# 6 MG CELESTIAL ROAD GROUND STORAGE TANK

TOWN OF ADDISON  
 DALLAS COUNTY, TEXAS  
**6 MG CELESTIAL ROAD STORAGE TANK**

# ONE 6.0 MILLION GALLON WATER STORAGE TANK CONTRACT NO. 86 PE 004 WITH TOWN OF ADDISON, COUNTY OF DALLAS, TEXAS CONSULTING ENGINEERS: GINN INC.

## PRELOAD WORKING DRAWINGS

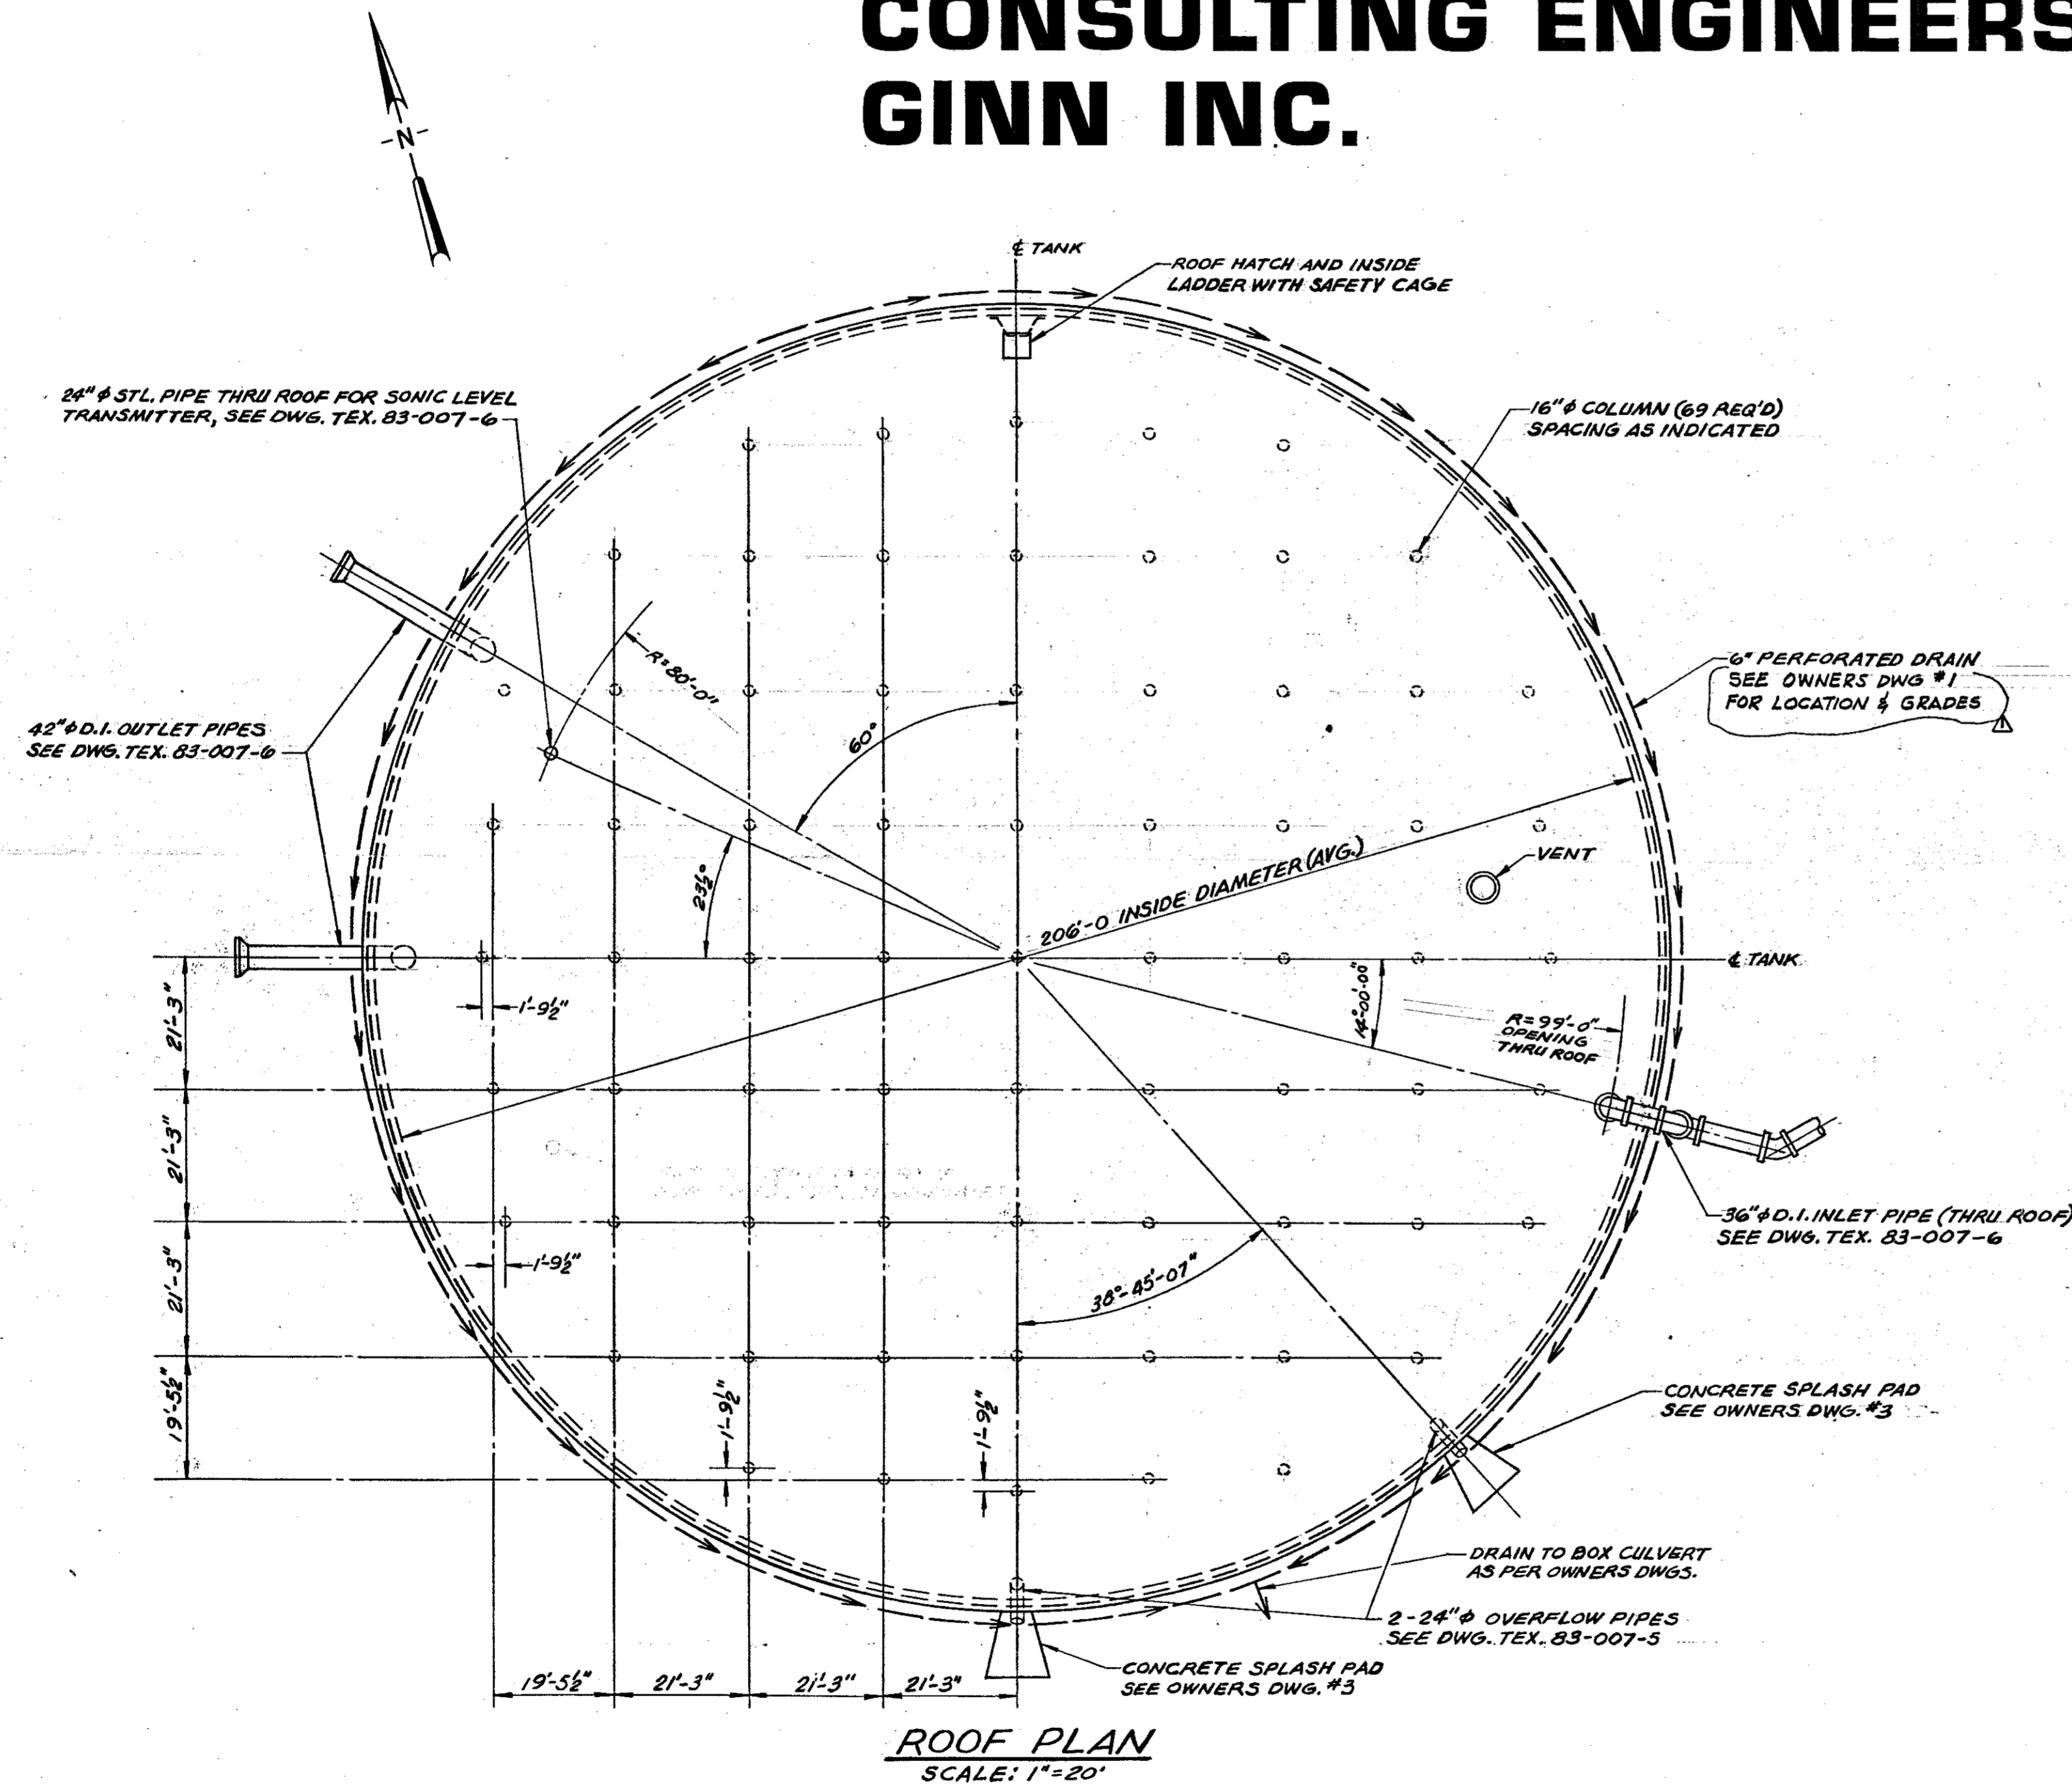
VERNON SAYS REVISION NOT NEEDED TO REVEAL BRASS TANK - PHONE 5-17-86

REVISIONS					PRELOAD		WORKING DRAWING			
NO.	DATE	DESCRIPTION	BY	CKD	839 STEWART AVENUE, GARDEN CITY, NEW YORK, 11530		ONE 6.0 M.G. WATER STORAGE TANK ADDISON, TEXAS			
1	5/13/86	REV. PERF. DRAIN; ADDED ELEV.'S ON TANK ELEV.	E	RAO	THIS DRAWING IS THE PROPERTY OF THE PRELOAD COMPANY, INC. AND/OR PRELOAD TECHNOLOGY, INC. AND IS SUBJECT TO RETURN ON DEMAND. IT CONTAINS FEATURES OF DESIGN WHICH ARE FULLY COVERED BY PATENTS AND PATENTS PENDING AND COPYRIGHTS. IT IS SUBMITTED FOR USE ONLY IN CONNECTION WITH PROPOSALS OR CONTRACTS OF PRELOAD OR ITS LICENSEES UPON THE EXPRESS CONDITION THAT IT MAY NOT BE USED ON ANY OTHER DIFFERENT PROJECTS WITHOUT PRIOR APPROVAL OF PRELOAD.		GENERAL ARRANGEMENT			
							DRAWN: PV	SCALE: AS NOTED	CONTRACT NUMBER: 86 PE 004	
							DESIGNED: FD	APPROVED:	DRAWING NUMBER: TEX	
							CHECKED: RAO	DATE: 4-24-86	DRAWING NUMBER: 83-007-1
